## STAFF REPORT COMMUNITY DEVELOPMENT DEPARTMENT

HEARING DATE: 1/11/2022  
 TO: Mayor & City Council  
 FROM: Alan Tiefenbach  
 208-884-5533  
 SUBJECT: MDA, PP, RZ - H-2021-0086  
 Apex East Subdivision  
 LOCATION: Parcel #S1405120902, located on the south side of E. Lake Hazel Road between S. Locust Grove Road and S. Eagle Road

B. Preliminary Plat (date: 10/11/2021 1/11/2022)

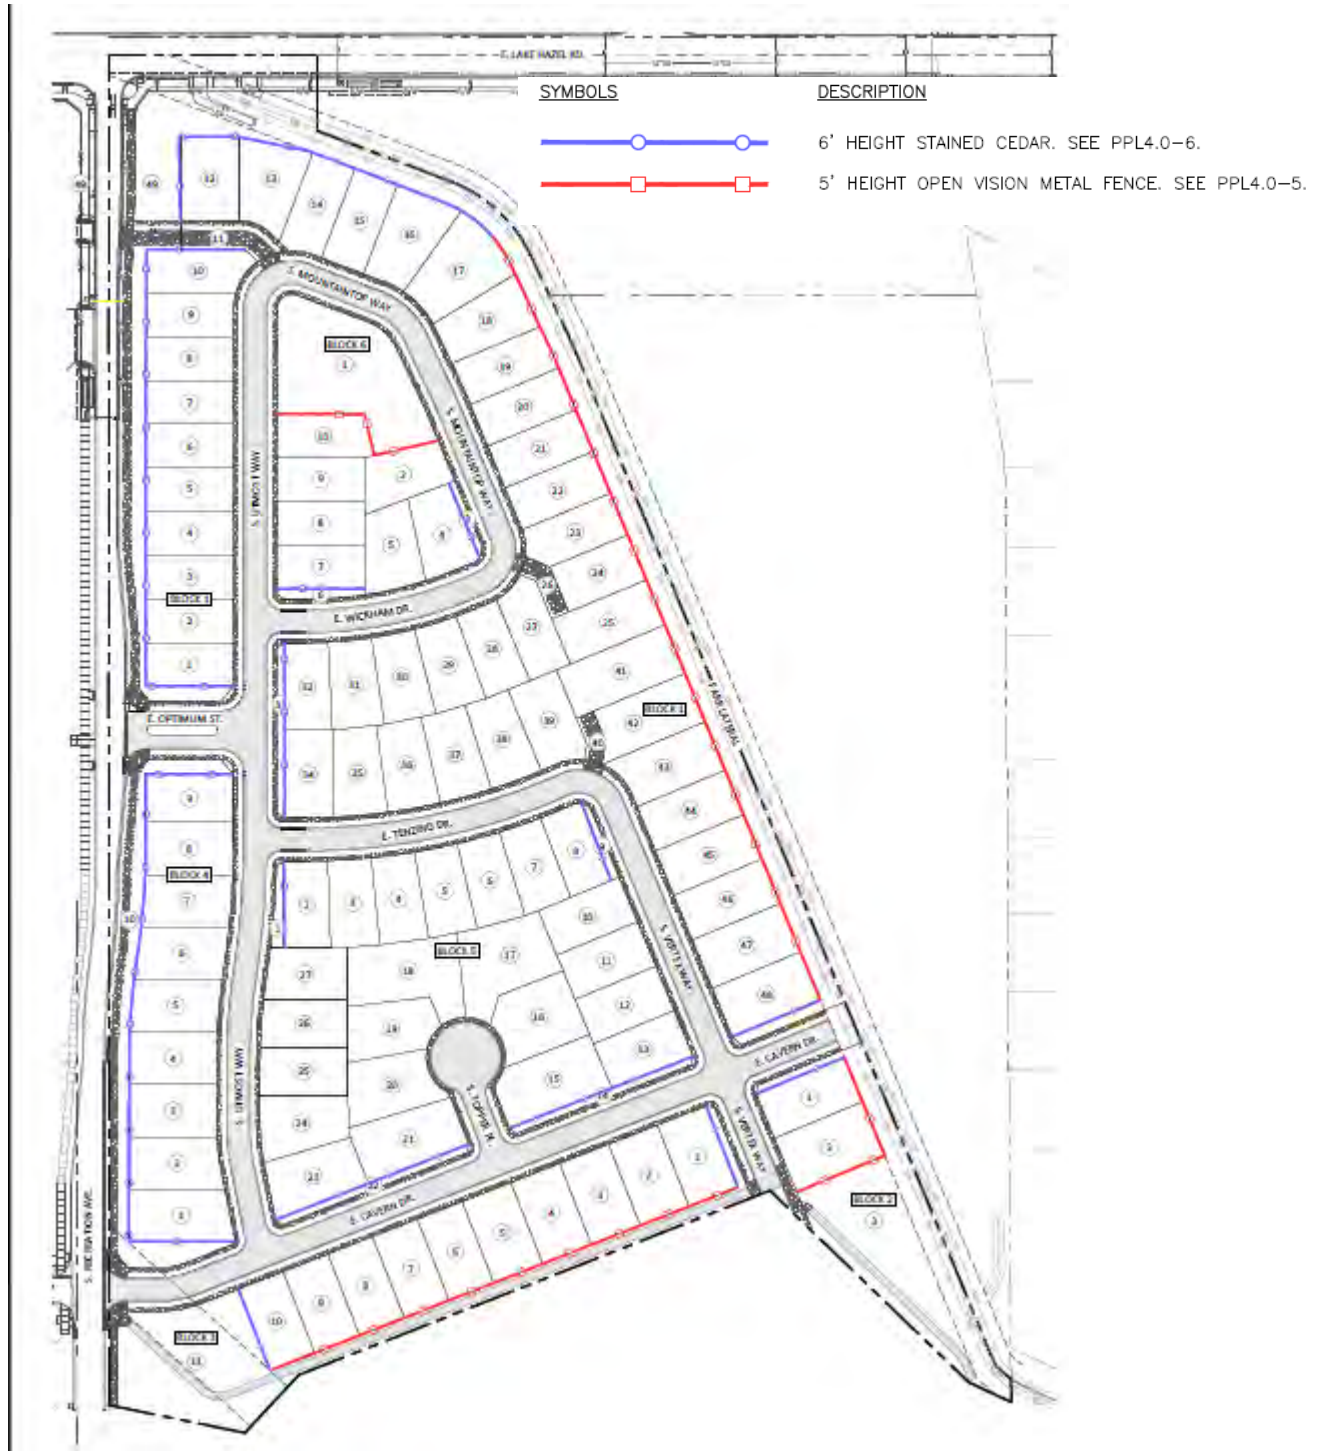
The elevations that were submitted suggest single family attached, although the plat as submitted does not reflect an even number of lots and does not indicate which lots would contain the attached product. Prior to Council, the applicant should revise the plat to depict the single family attached lots (zero setback side lot lines).

- a. Commissioners expressed concerns with lots in the vicinity of the common drive at the northwest portion of the property, and there could be future issues with parking and trash services. They also commented it appeared too many lots were “squeezed in there.” They suggested eliminating the common drive and creating more “pie shaped” lots in this area and /or putting a “knuckle” in there.

- b. Commissioners suggested the applicant make additional adjustments in the circle surrounding Lot 1, Block 6 to create more useable open space.
- c. Commissioners commented that they would prefer the common drives to be eliminated.

- d. Commissioners suggested putting a pathway adjacent to the Farr Lateral Easement, directly behind all the houses to the east.
- e. Commissioners did not support the precedent of continuing to rezone R-4 property to R-8.

2. The Preliminary Plat included in Section VI, dated 10/11/21, is approved with the following revisions:
    - a. ~~The plat should indicate which lots will contain single family attached (zero side lot lines).~~

- b. Add notes which indicate Lots 3 and 50 Block 1, Lots 10 & 11 Block 4, Lot 1 Block 6, are common lots which will be owned and maintained by the homeowner's association.

- c. All utility easements reflected on the utility plan shall be included on the plat.
    - d. ~~Prior to Commission, the plat and landscape plan shall be revised to provide access to some or all of the open area shown along the Farr Lateral. Only areas accessible and useable as open space to the residents for active or passive recreation should be included on the open space exhibit.~~
